Correction: CO₂ decomposition in a packed DBD plasma reactor: influence of packing materials

Correction for 'CO₂ decomposition in a packed DBD plasma reactor: influence of packing materials' by Debjyoti Ray *et al.*, *RSC Adv.*, 2016, 6, 39492–39499.

Fig. 3 Lissajous figure for DBD reactor as a function of voltage.

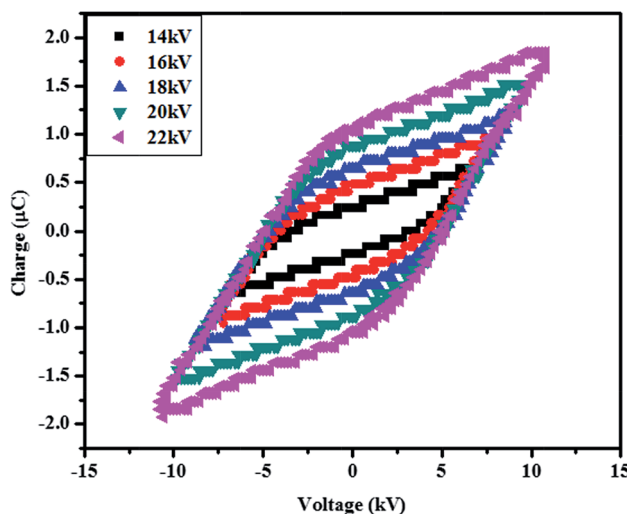
Fig. 3, 4, 5 and 6 should be replaced with the following figures:
